## OPTION 1 COMMENTS

## FRAMEWORK PLAN AFTER FULL BUILDOUT

## OPTION 2 COMMENTS

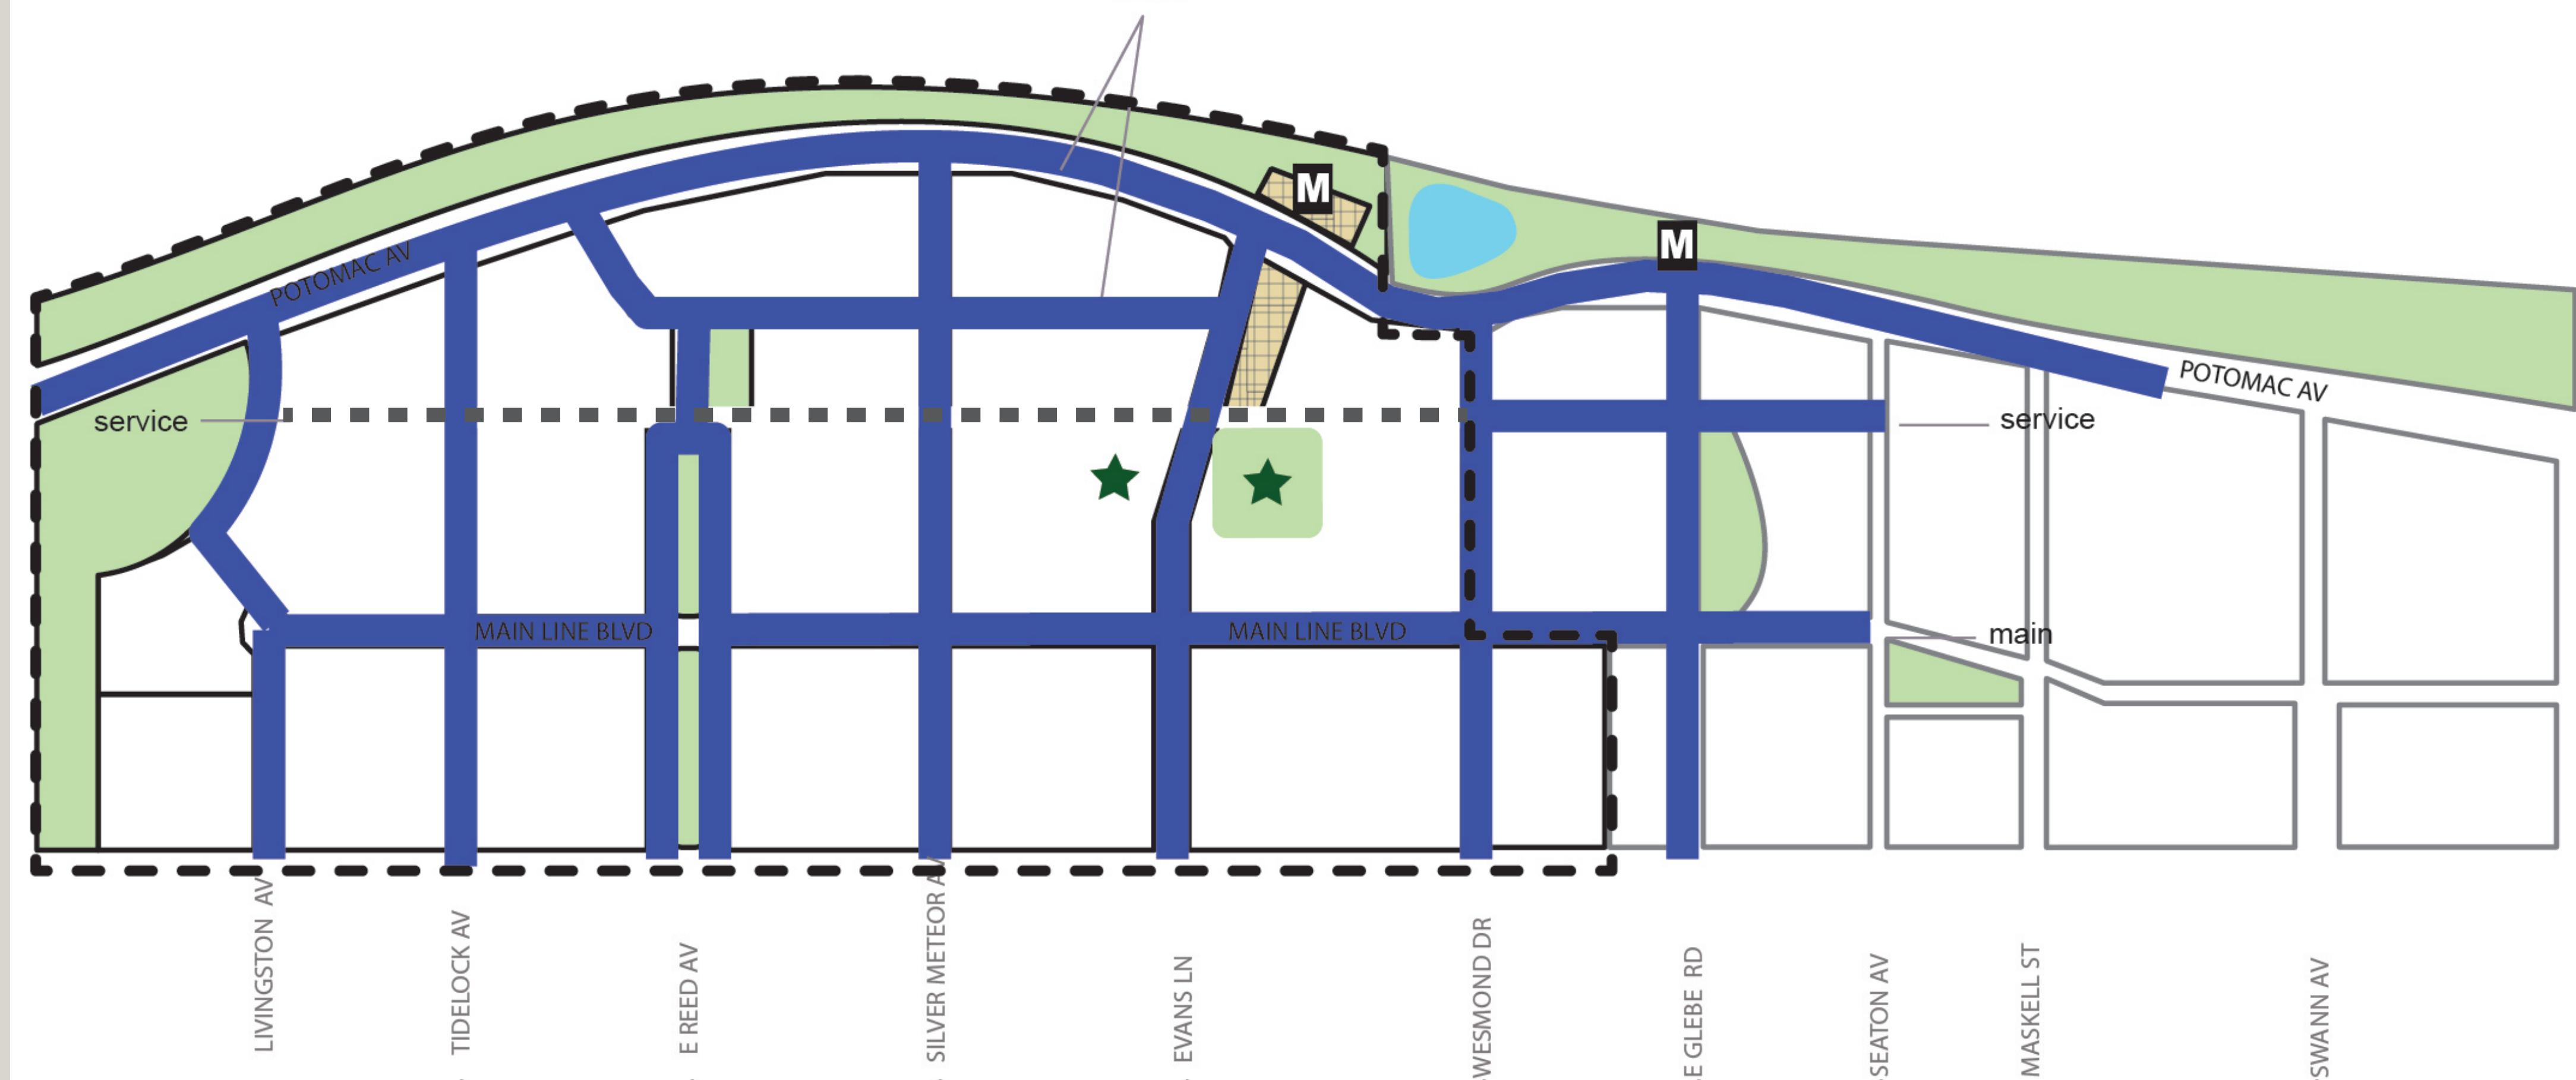
- Reducing width of Potomac Ave can improve pedestrian/transit experience of both
- Explore possibilities of Option 1 further to create destination for retail

- Option 1 better for transit – easier drop off for cars
- Pedestrian Environment (in Option 1), can explore options for improvement. Smaller blocks aren't necessarily better

- Don't like the concept of a loading alley in Option 1 – would prefer a skinny street, some loading dispersed might be okay, even on Park
- In Option 1, could explore Evans as the BRT stop

- Service alley in Option 1 doesn't make sense, doesn't seem like apples to apples. Also don't like long blocks created as a result
- Option 1 grid shouldn't depict the service alley as a different street classification

- Option 1 is the same as Option 2 in terms of connectivity
- Potomac Avenue and Potomac Yard Park have a symbiotic relationship in the 2010 Plan. Like the clear separation of public/private;

- In terms of transit and pedestrian, both options are equal
  - In terms of Metro Zone landing, Option 2 favorable

- Legitimate concern to cross very wide road at Metro in Option 1. However, the urban design/unique character of park/road continuity is a positive
- Option 1 feels less pedestrian friendly and more vehicular friendly.
- Option 1 eliminates most of the pedestrian positives by placing the Metro station, with its foot at a major road. This road would cut off integration of the Metro pavilion with the rest of the development and would isolate the park in this section as well.
- Option 1 gets BRT closer to the Metro station, but I do not see this as a guiding force here since, as I understand it, the purpose of BRT is to get from point to point and not necessarily to get to a Metro station for further transit. Option 1 also gets local bus circulation a bit closer, but, again, I think pedestrian safety and walkability trumps both BRT and local bus circulation.

### FRAMEWORK PLAN AFTER FULL BUILDOUT

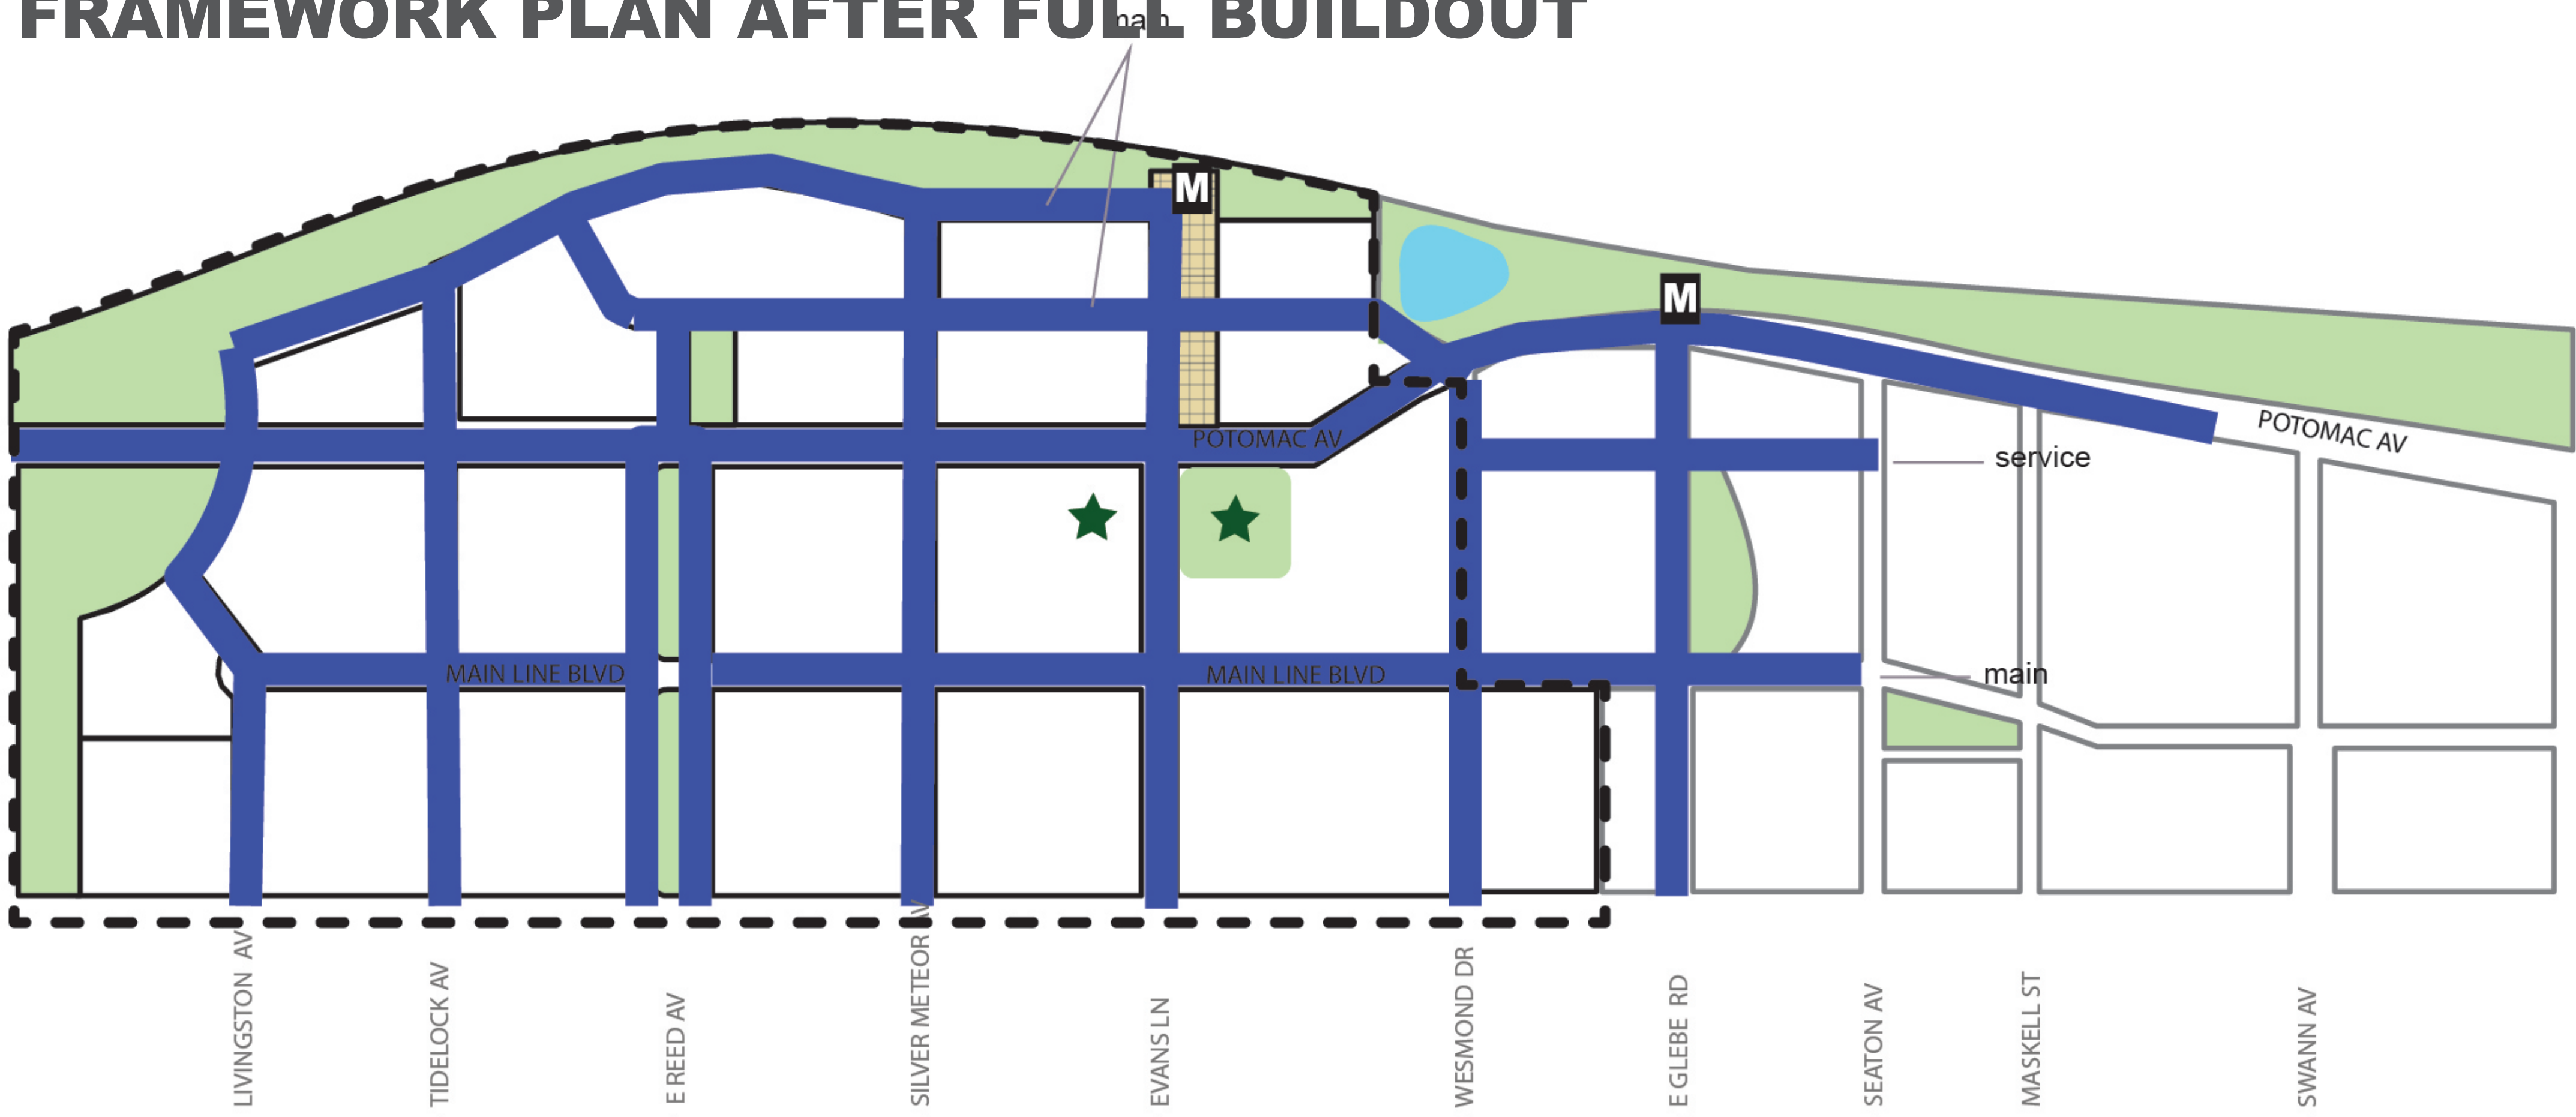
- Existing residential areas east of Route 1 and access to NPY – don't like the many wide roads to cross

- Would prefer Option 2 with more of focus on pedestrian/bike access and connectivity

- BRT width is a concern for both Option 1 and 2. Phasing has a major impact so that Option 2 provides more flexibility in determining the final width needed for the BRT.

- I like how Option 2 immediately provides access to open space and destinations (future retail, residential, hotel, office) while the BRT is visible from the Metro entrance/exit. I prefer that we have a more vibrant experience at the entrance/exit than the alternative which is to cross multiple lanes of traffic. If one wants to cross multiple lanes of traffic, use the southern entrance/exit of the future Potomac Yard Metro.

- Both Options can score well in this category in terms of accommodating an integrated transit system (Metro, BRT, and local bus circulation). When pressed to choose, I choose Option 2. I like how the BRT is closer to the middle of the planned development area as depicted on the Option 2 Framework Plan.

- Placing Potomac Avenue at the eastern most side of NPY was probably the right thing to do at the time in 2010. I'm not certain any of us on the Advisory Group were convinced the Metro Station was going to be built. So why not design a road that quickly moves a vehicle from north to south or south to north. Made sense at the time. In Option 2 I see an opportunity to locate activities and uses directly adjacent to the Metro terminus. This is a long way of saying Option 2 is there first and foremost for the pedestrian experience and lastly for the car experience.

- Now that we are certain about the arrival of a Metro Station and having firsthand experience with Pulte's section of Potomac Avenue, I believe locating Potomac Avenue to its current physical location is an improvement over the 2010 Plan.

- Adopting Option 2 will not compromise the integrity of the 2010 Plan.

- As I said at the last meeting when we were focusing on the north pavilion for Metro, I think we have a unique opportunity to locate in a way that integrates Metro, the development, and the park when we focused on the location that would place the pavilion and plaza just north of the stormwater pond, with an extension of the plaza across the road.

This is translated best in the July 25 exercise with Option 2. Metro, connected to the park, and the development, with a minor road to cross is the ideal proposition to achieve best pedestrian access.

- Option 2 sets the standard for this area and defines the importance of pedestrian and bike access. Even if BRT and buses are a bit further west, we are only talking two blocks away. Even if Option 1 may score higher here, my vote is still for Option 2 on this issue as well.

- Potomac Avenue should continue on its current course (Option 2). Once the full buildout on both sides of Potomac Avenue occurs, I think this effect will necessarily slow down traffic and make it less of a dividing line when we look at North Phase I and the future phases. If Potomac Avenue were curved to hug the park, this sort of calming down would never occur. The park and the metro station would be divorced from the rest of the development.

- Option 2 is the best option to achieve the stated goals of the 2010 plan. Option 2 moves the potential dividing line to where it can be integrated into the overall design, as opposed to acting as a boundary.
